# **Nomad**

TRANSMITTAL LETTER  
FOR  
SERVICE BULLETIN NMD-53-11 Rev 1

## FUSELAGE - STUBWING - BATTERY SUPPORT STRUCTURE MODIFICATION (Mod N735)

**NMD-53-11**

Figure 1 Existing Battery Tray Installation

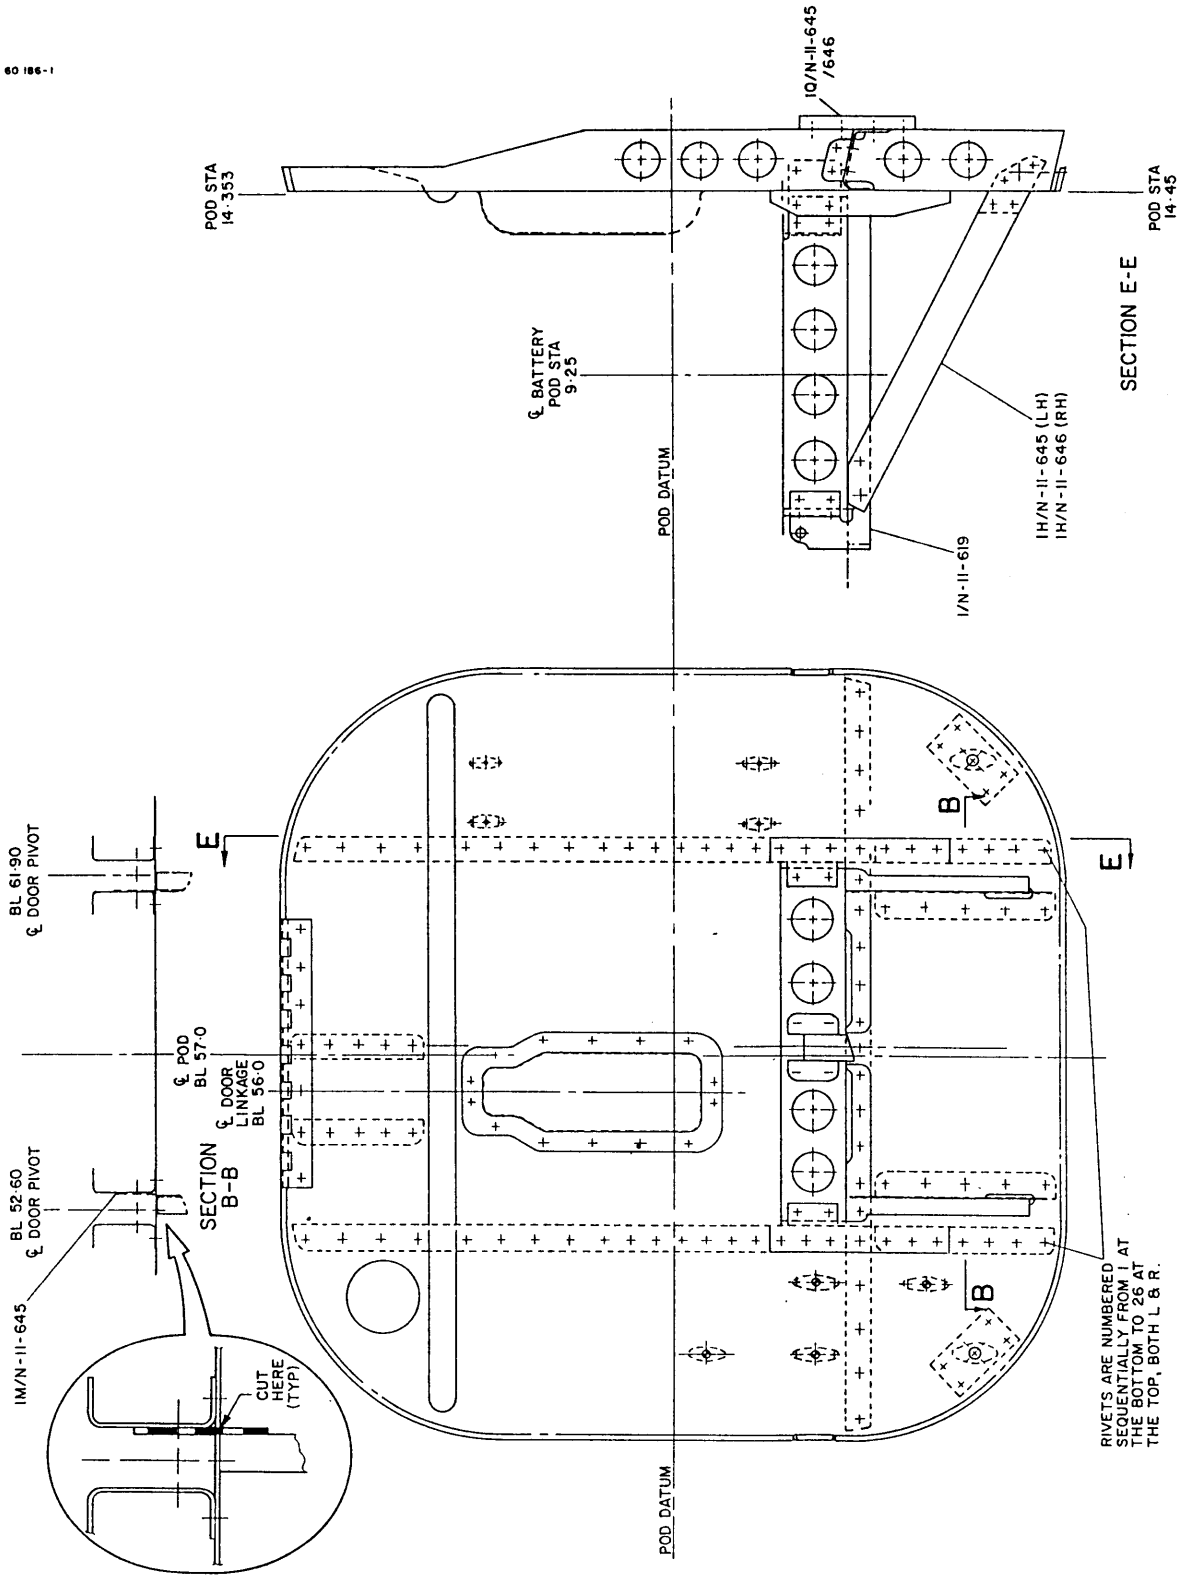
- F. Refer to Figure 1. De-rievet and remove existing Battery Tray PN 1/N-11-619 complete, together with Tray Support Channels PN 1H/N-11-645/646 and Tray Support Angles PN 1J/N-11-645/646.
- G. Refer to Figures 2 and 4. Bench assemble Tie Rod Support Channel PN 1C/N-11-619 and Tie Rod Top Hats PN 1D/N-11-619 to Battery Tray PN 1A/N-11-1327.
- H. Refer to Figure 4. Attach Battery Support Strips PN 1J/N-11-619 and PN 1K/N-11-619 using PLIOBOND 20 adhesive or suitable equivalent.
- I. Refer to Figure 1, Section B-B and Figure 5. Trim Tray Support Plate PN 1M/N-11-646 and dress until flush with face of frame at Pod Sta 14.45.
- J. Fit Side Supports PN 1C/N11-1327 and PN 1D/N-11-1327 as follows:
  - (1) Mark the new, lower and upper tie plate slots as indicated in Figures 2, 3 and 4. Drill and manufacture the four new tie plate slots.

- (2) Seal redundant slots with Scotchcal tape or a suitable sealant.
  - (3) Refer to Figure 1. Drill rivets 2, 3 and 4 and 12 to 19 both L and R.
  - (4) Refer to Figure 4 and 6. Position RH upper tie plate and clamp to upper pivot support in pod.

Figure 4 New Battery Tray Installation

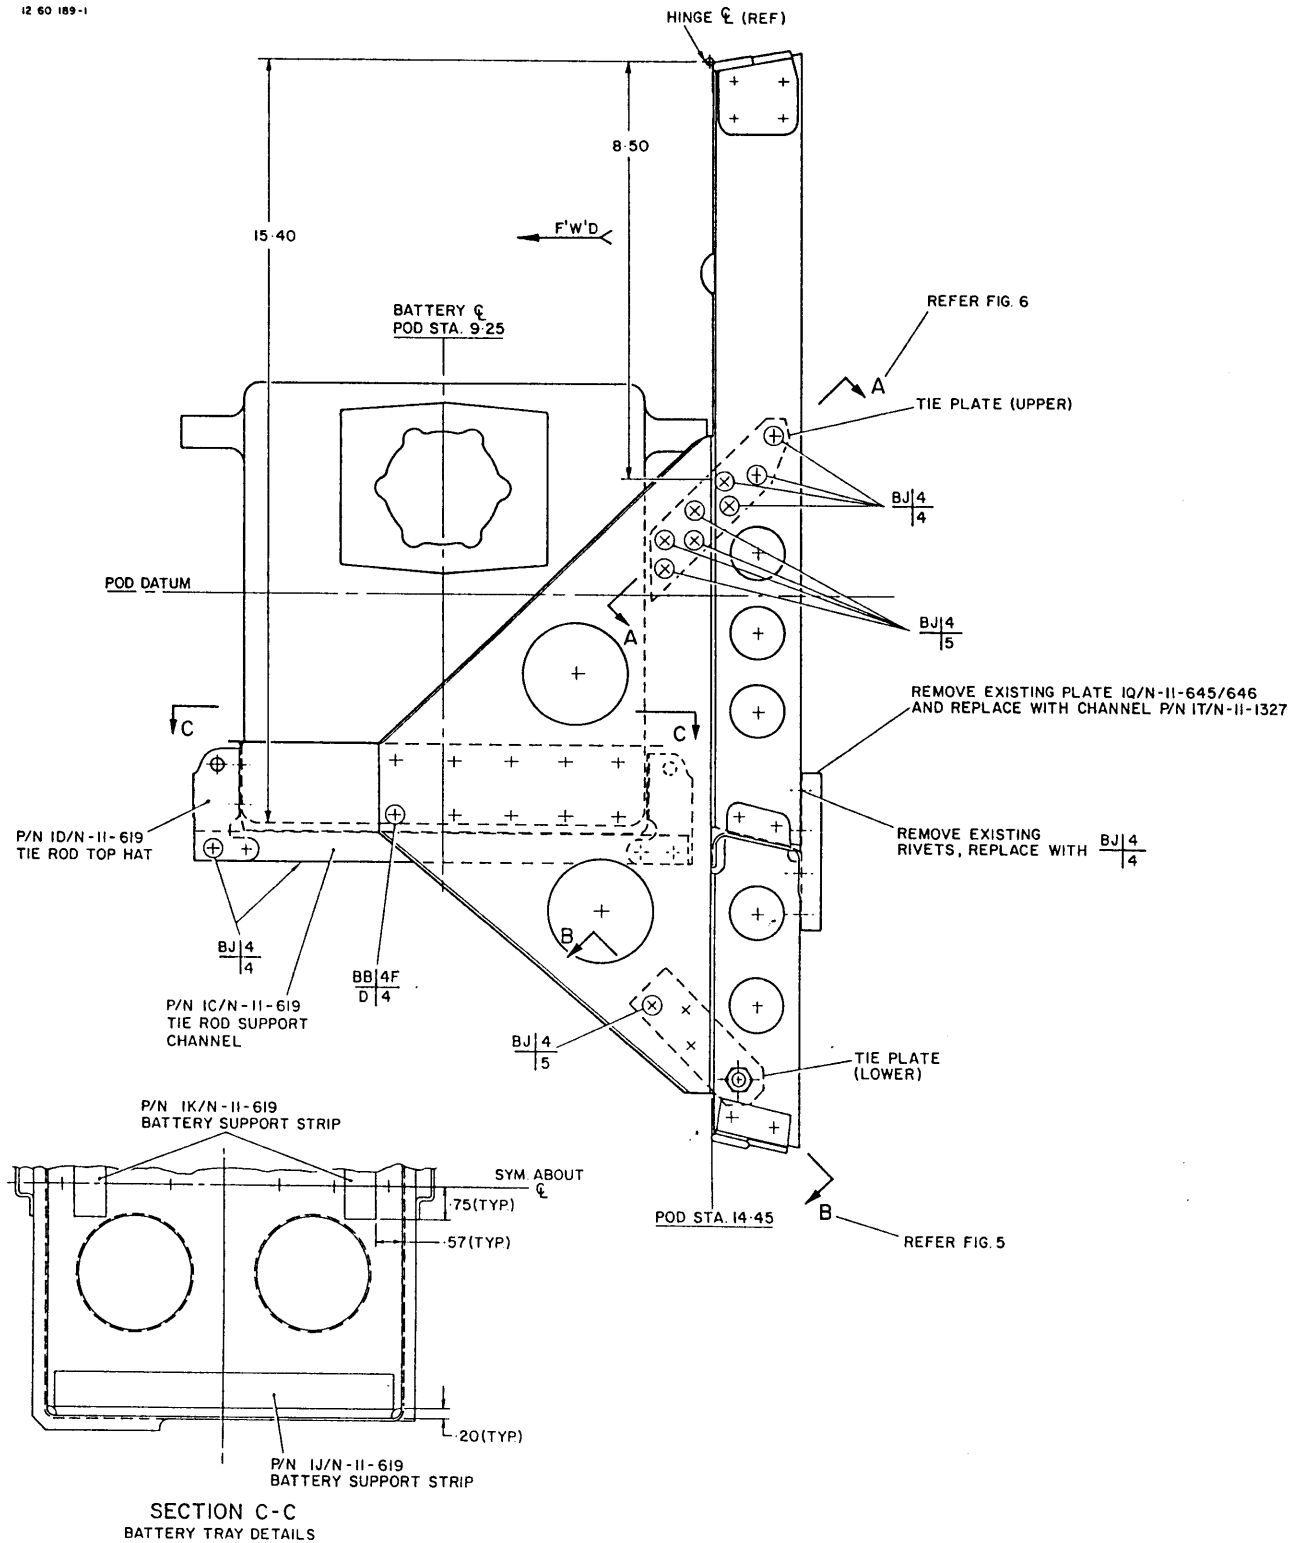
- K. Fit Battery Tray Assy PN 1A/N-11-1327 as follows:
- (1) Refer to Figure 4. Position battery tray assy and clamp to L and R side supports. Ensure the floor of the tray is at right angles to pod Sta 14.45, is 14.50 in below hinge PN 1B/N-11-620 and the fore and aft battery tray centre line is 5.20 in forward of Pod Sta 14.45.

- L. Refer to Figures 1 and 4. Remove existing LH and RH Pivot Support Butt straps PN 1Q/N-11-645/646 and replace with Channel PN 1T/N-11-1327.
- M. Refer to IPC Chap 52-80-01, Figure 1. Rework the two spacers PN 1A/N-11-713, which fit nearest the tie plate, by filing or machining 0.040 in from this length. Re-identify the modified spacers as PN 1K/N-11-1327.

Figure 5 Main Landing Gear Door Hinge

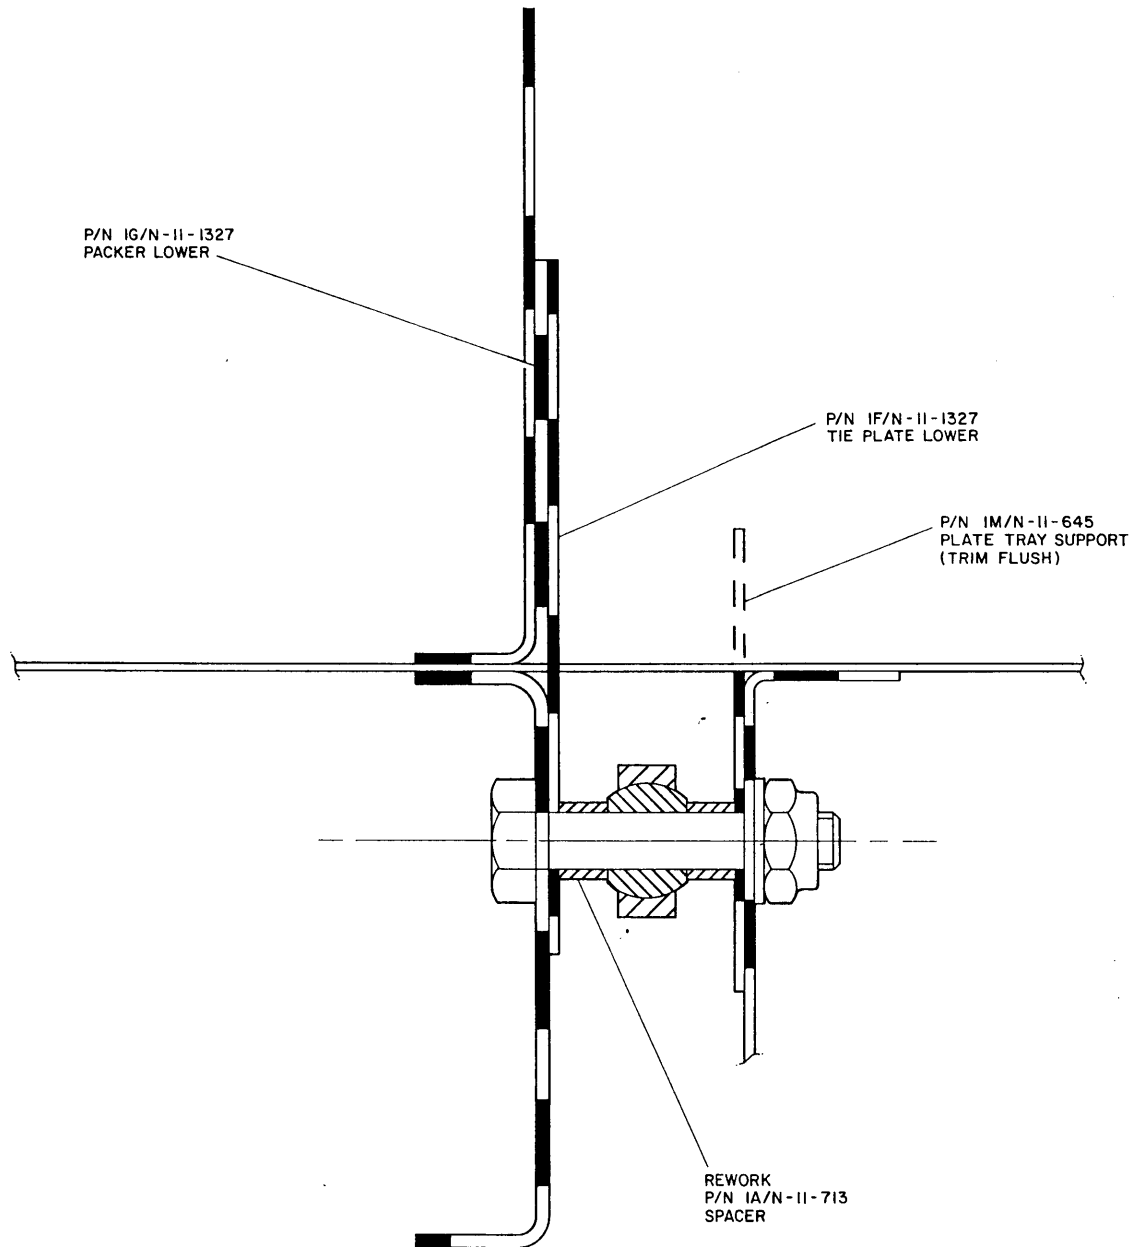
- (5) Refer to Figures 4 and 5. Position RH lower tie plate and clamp to lower pivot support in pod. Use pivot bolt to ensure correct alignment of tie plate hole.

- P. Refer to MM Chap 32-10-15 and this Service Bulletin Figure 5. Install forward LH main landing gear door and adjust/test.
- Q. Refer to MM Chap 24-30-01. Install battery. Replace any battery cable/vent retaining clamps that may have been removed.

Figure 6 Tie Plate Upper

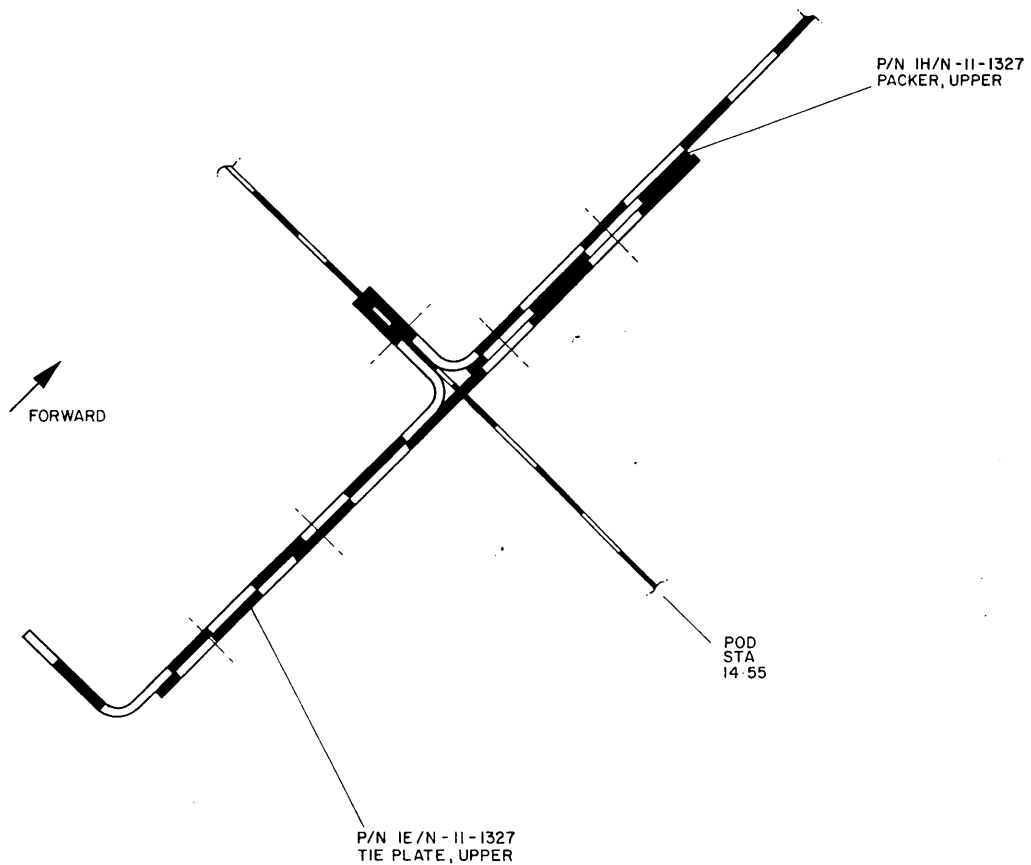
- (6) Refer to Figures 4, 5 and 6. Position RH side support. Insert upper and lower Packers PN 1G/N-11-1327 and PN 1H/N-11-1327 and clamp.
  - (7) Ensure tie plates, packers and side support are correctly positioned. Back drill rivet holes on side support using a right angled drill. Drill all other rivet holes.
